ADDENDUM NUMBER ONE

Indiana University
Launch Accelerator for Biosciences
1302 Indiana Ave.
Indianapolis, IN 46202

Addendum Dated: OCT 16, 2025

IU Project #: 20250072
BSALS Project #: 00360481

S300

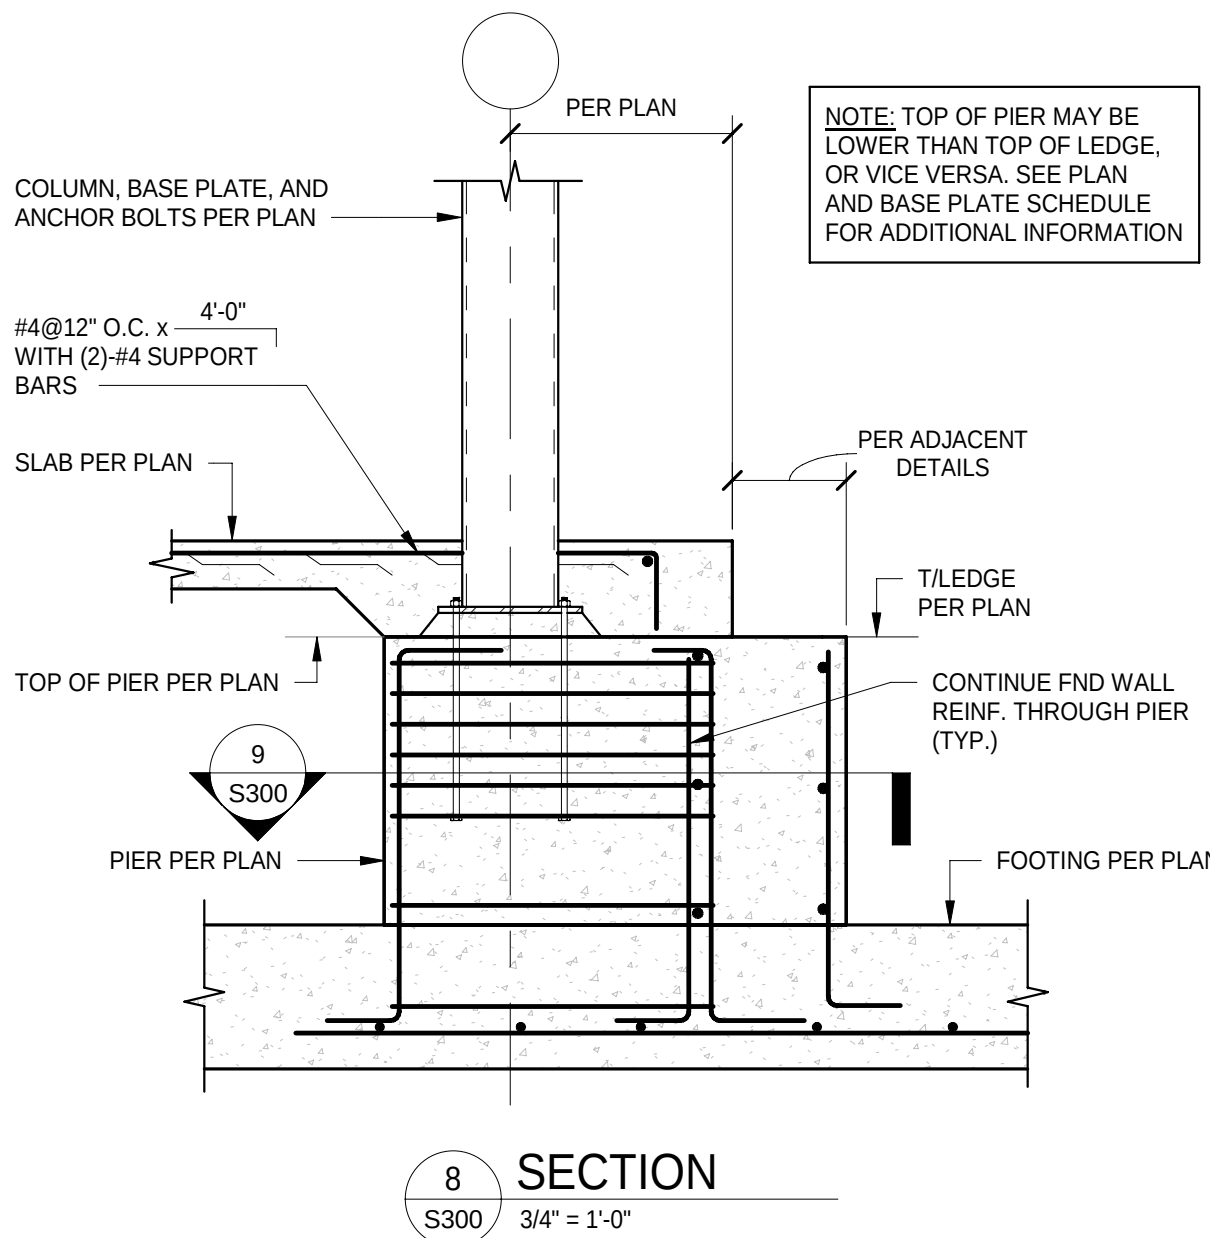
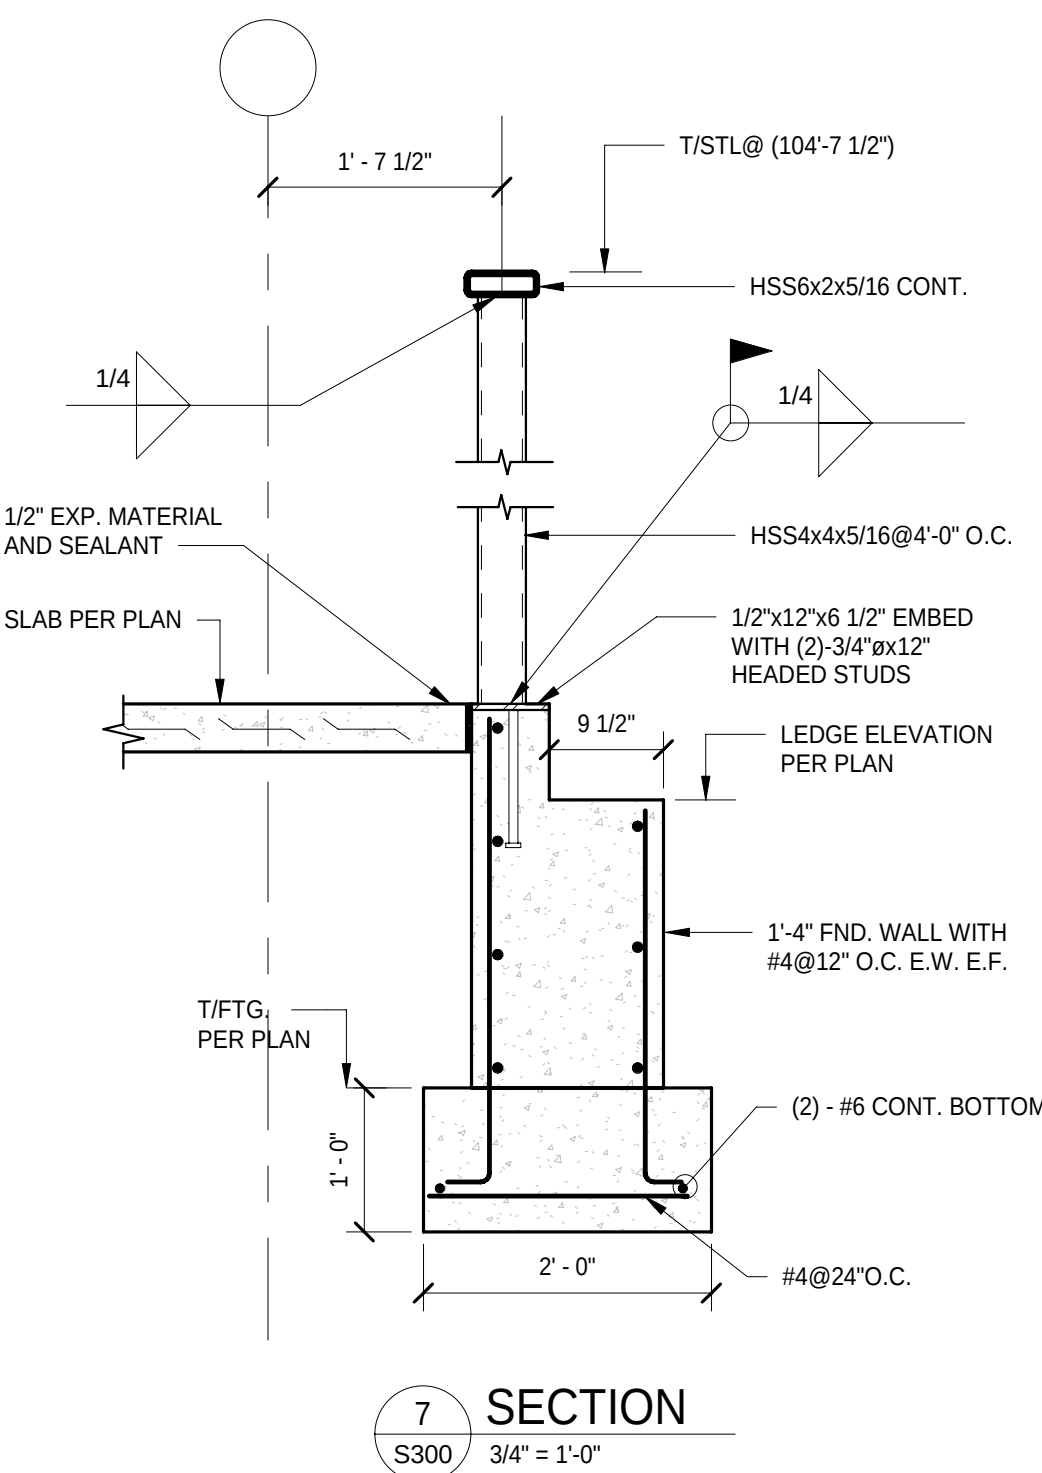
- j. Add brick ledge step along D line at 14 line as shown on the clouded portion of the attached revision drawing.
12. **Sheet S300:**
- a. Modify the "PER PLAN" dimension line on S300-06 as shown on the clouded portion of the attached revision drawing.

6 DETAIL
S301 3/4" = 1'-0"

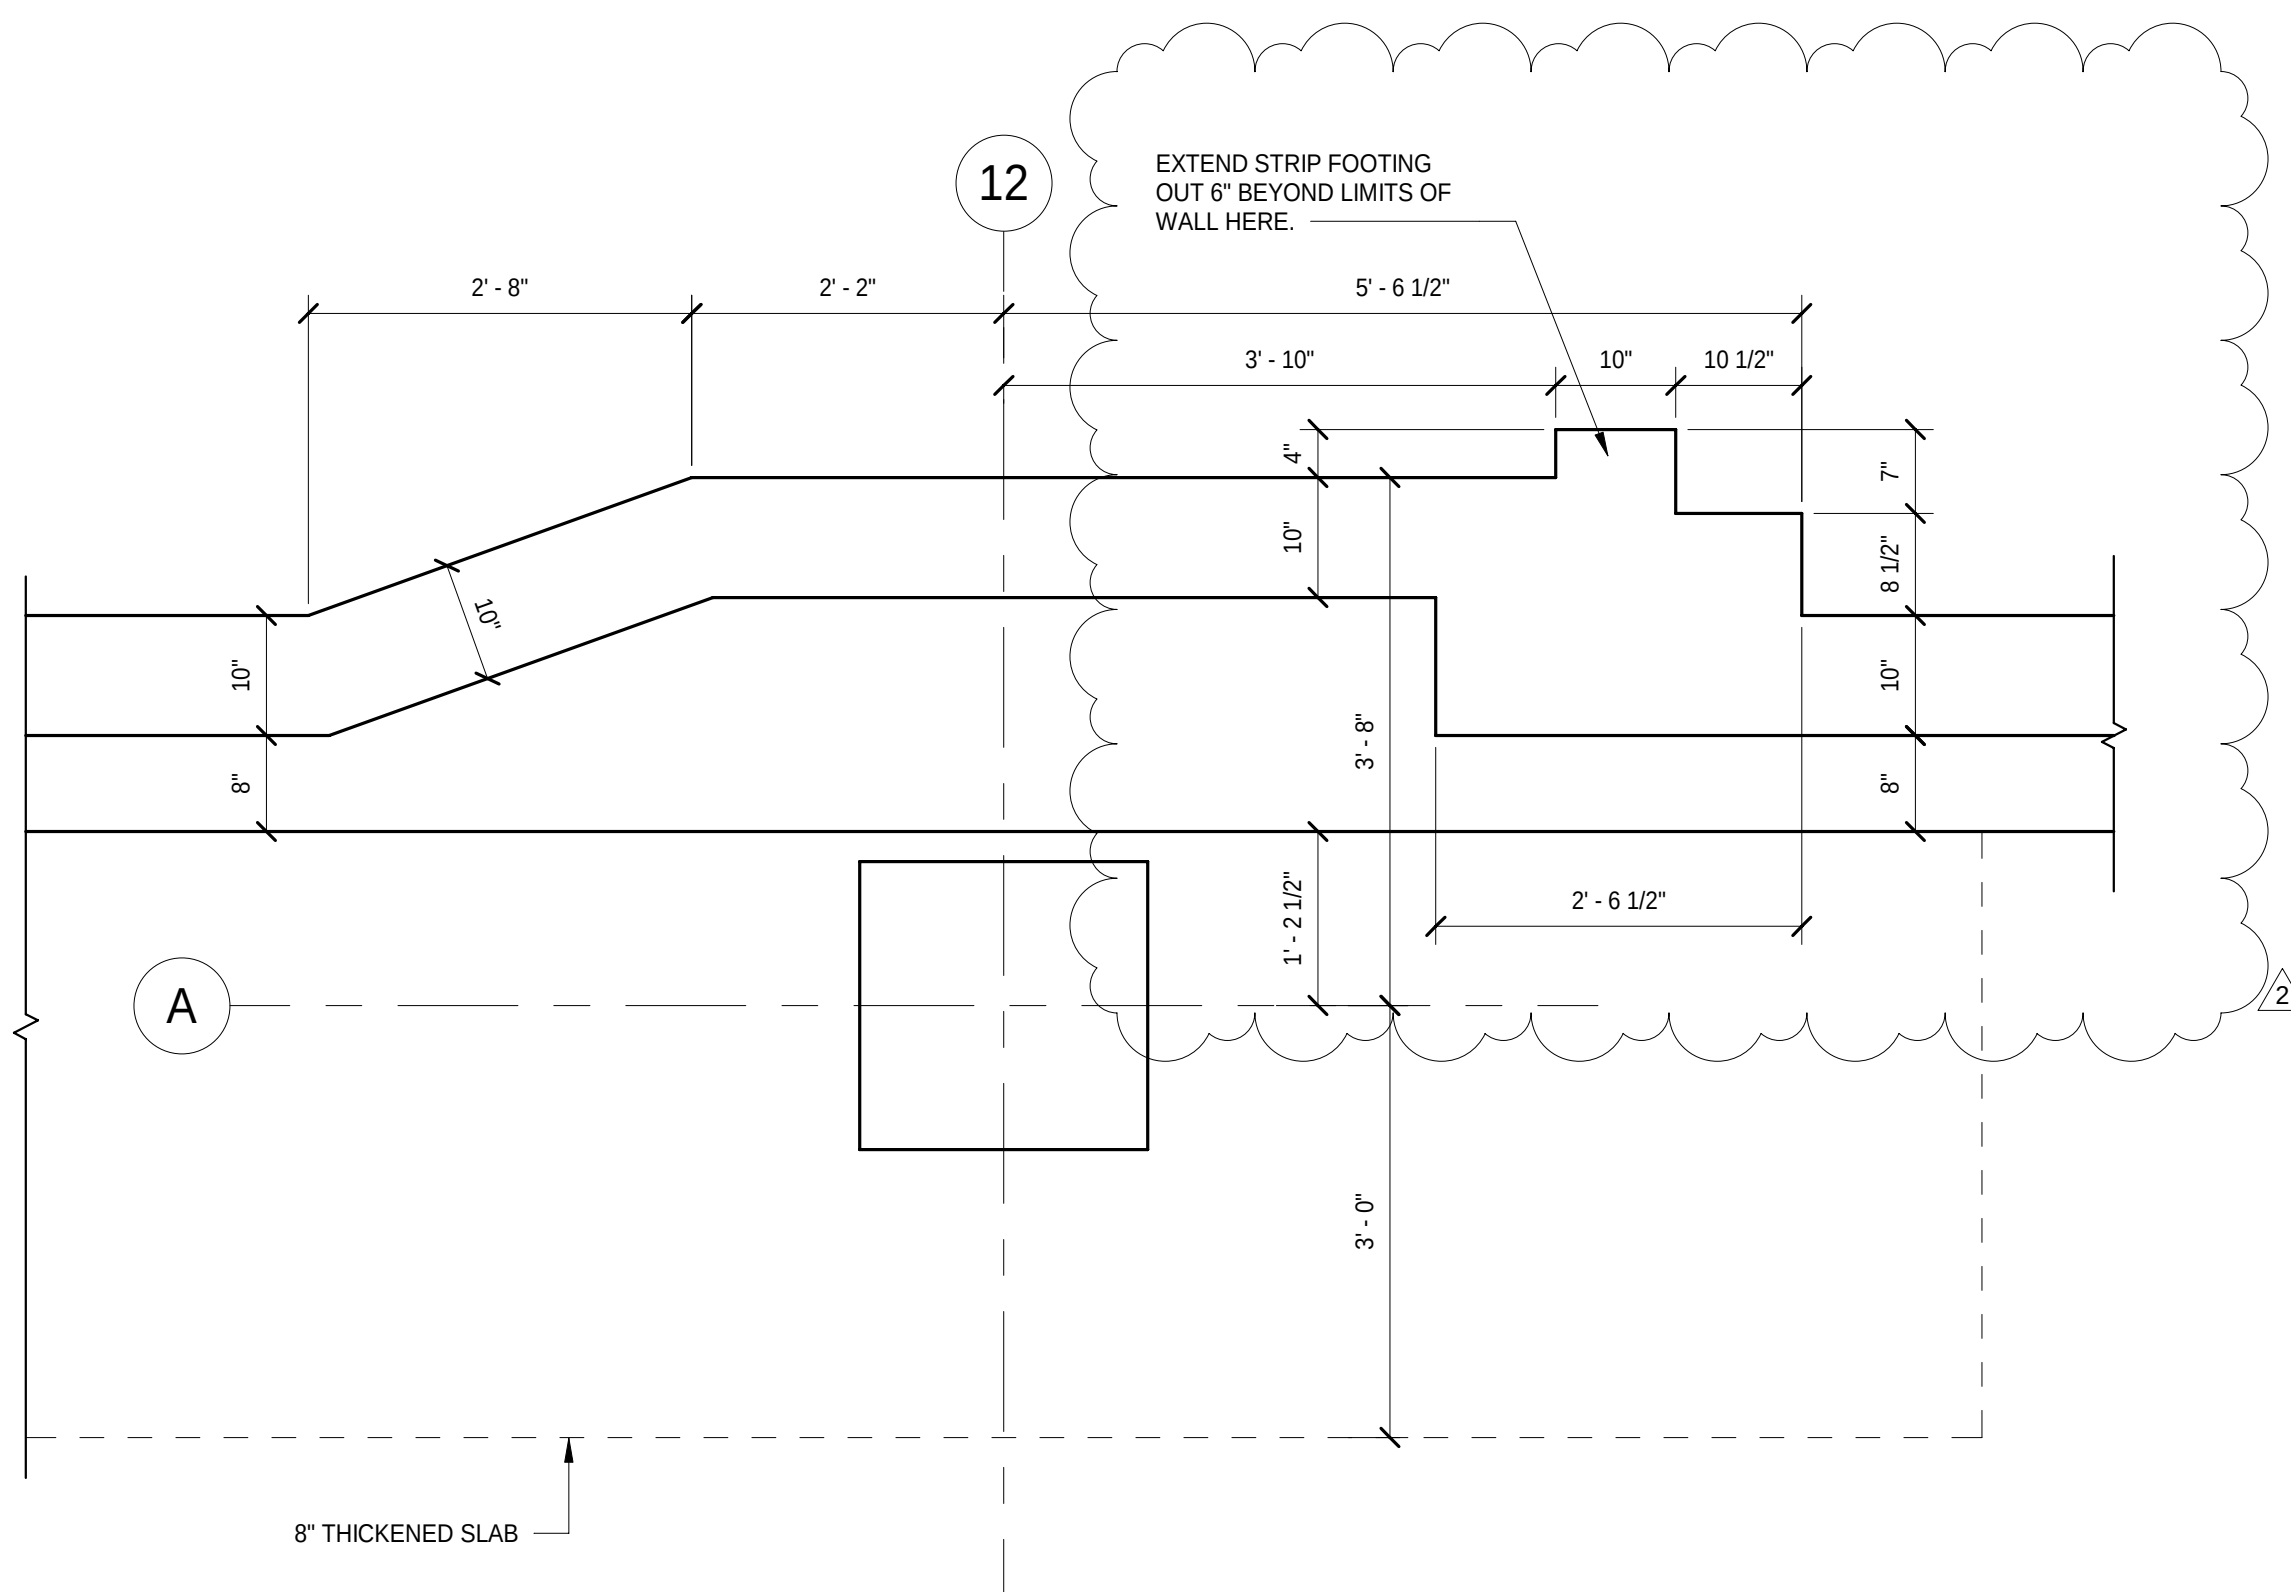
13. **Sheet S301:**
- a. Modify the dimensions on detail S301-06 as shown on the clouded portion of the attached revision drawing.
14. **Sheet S302:**
- a. Add the note to section S302-06 as shown on the clouded portion of the attached revision drawing.
